ACEEE Comments on EPA's Proposed Determination
Docket ID No. EPA-HQ-OAR-2015-0827
December 30, 2016

The American Council for an Energy-Efficient Economy (ACEEE) submits these comments in response to EPA's Proposed Determination on the Appropriateness of the Model Year 2022-2025 Light-Duty Vehicle Greenhouse Gas Emissions Standards under the Midterm Evaluation (PD), issued in November 2016.

Figure 1: Light Truck GHG emissions

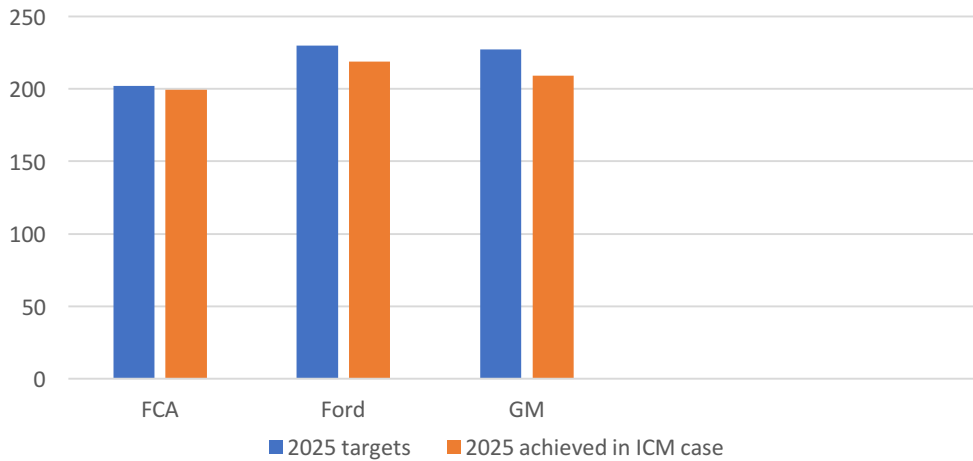
CAR also asserts that technology costs to meet the body-on-frame duty cycle required may be excessive and in particular that it will be challenging to substantially lower the coefficient of drag or add lower rolling resistance tires to these vehicles due to their unique duty requirements. However, the agencies’ compliance packages demonstrate in detail how these vehicles can meet their targets. In fact, in EPA’s compliance scenario, the light truck fleets of the U.S. manufacturers over comply, as shown in figure 1.

Figure 3: Average Vehicle Expenditure

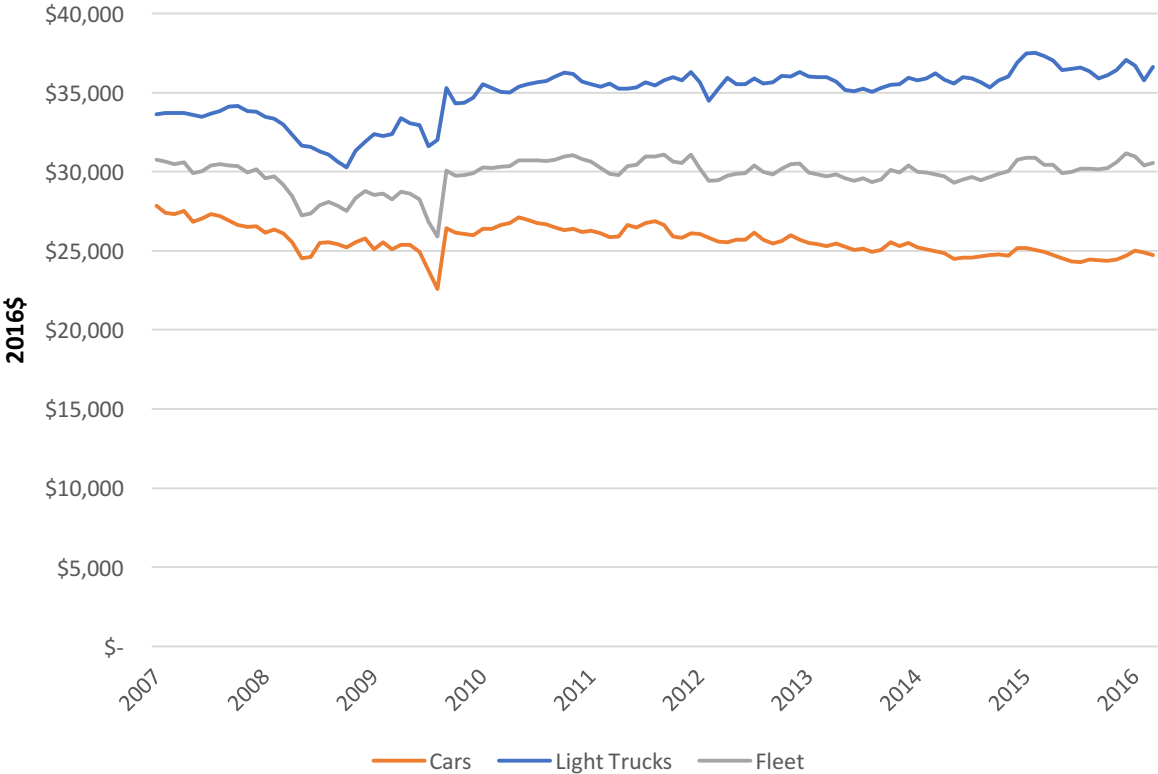
Since the recession, the average expenditure on cars has decreased, while the average expenditure on trucks has increased, as shown in figure 3. The average expenditure for all vehicles increased slightly, due in part to the increasing share of vehicle purchases that are light trucks, which cost more.
